Louisiana Energy Services, L. P.
National Enrichment Facility
NRC Docket No. 70-3103

Subject: Summary of 10 CFR 70.72 and Integrated Safety Analysis Summary Changes

1. Summary of 70.72 Changes
2. Environmental Report, Annotated Pages
3. Environmental Report, Replacement Pages
4. Safety Analysis Report, Annotated Pages
5. Safety Analysis Report, Replacement Pages

FIGURE 2.1-1

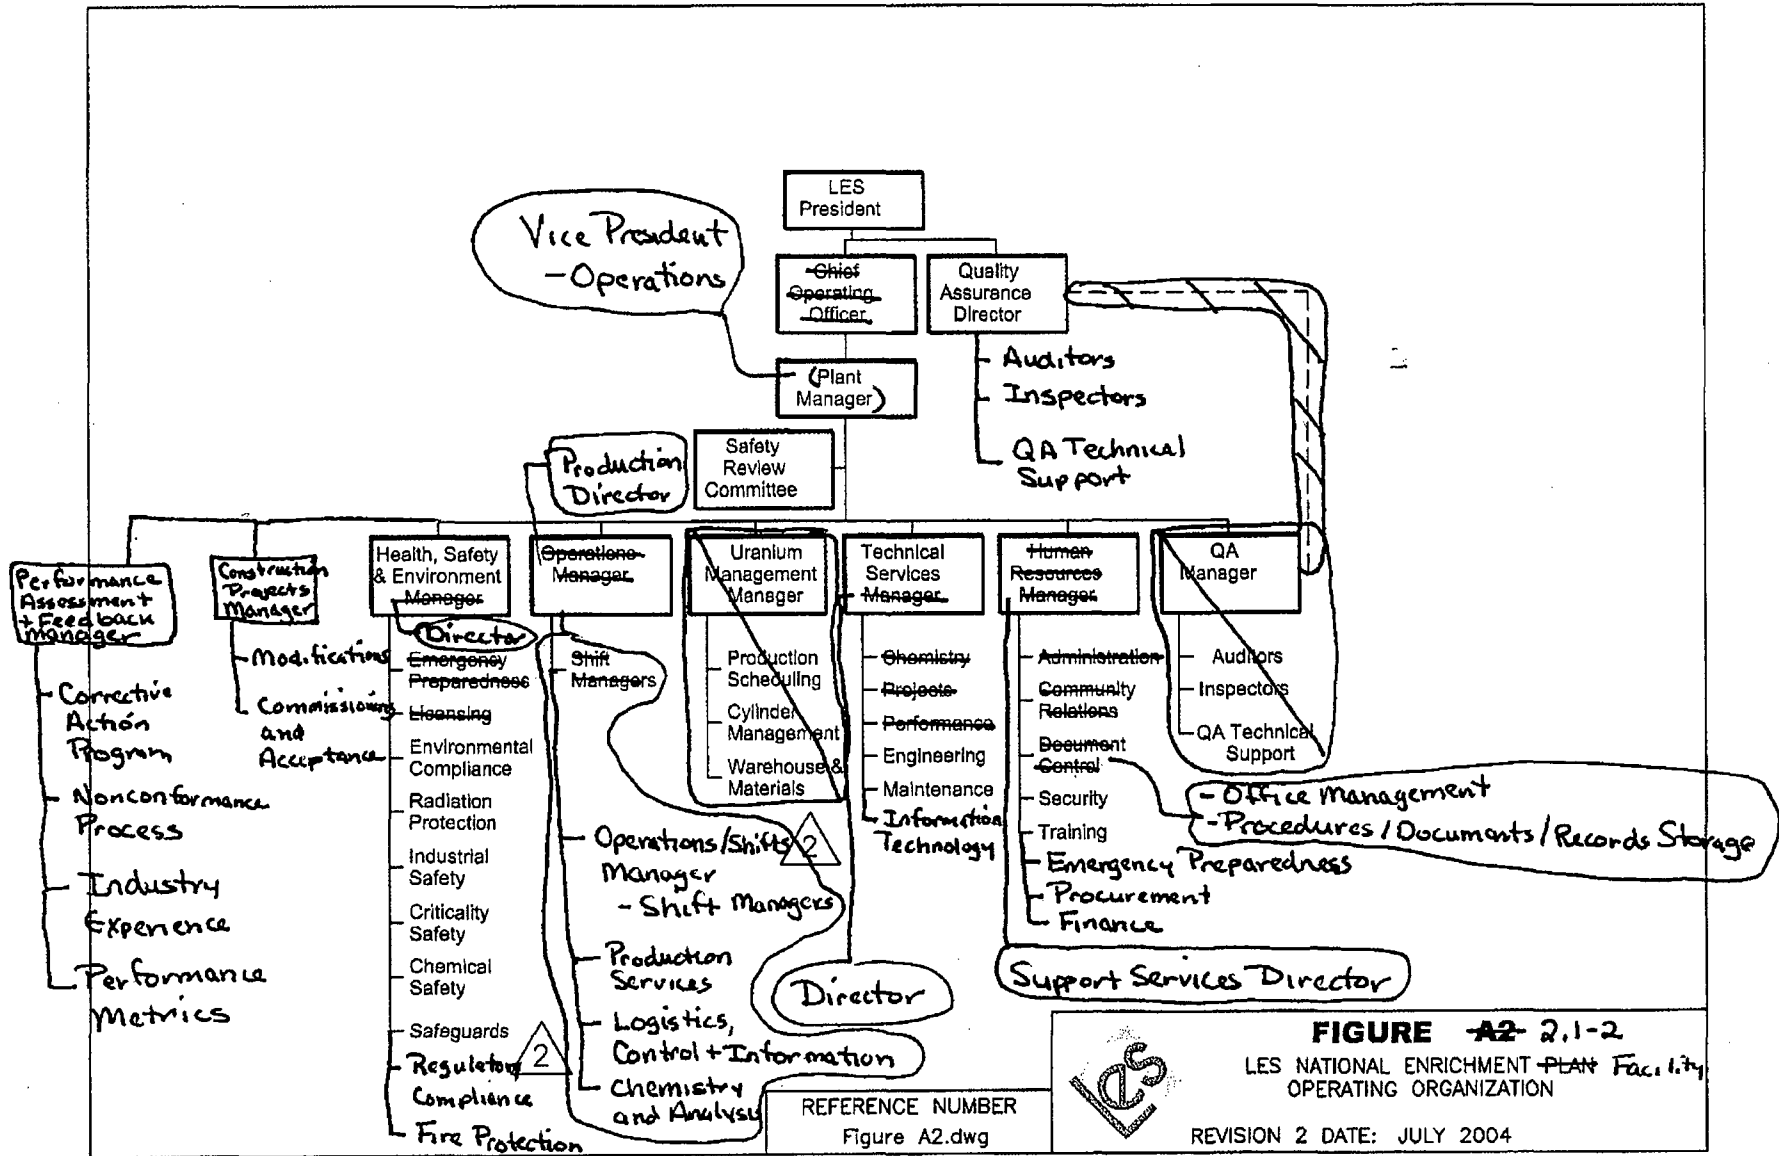
As shown in Figure 2.1-1, the ~~Engineering and Contracts Manager~~ Vice President - Project Management is responsible for managing the work and contracts with the Technology Supplier (Urenco), the Design Manager, Construction Manager, and other ~~and a select group of Project Managers. These Project Managers will be responsible for the areas of Procurement, Construction, Engineering, Project Engineering, Project Controls and Start-up.~~ The lines of communication of key management positions within the engineering and construction organization are shown in Figure 2.1-1.

The LES Corporate Organization and lines of communication are shown in Figure 2.1-1.
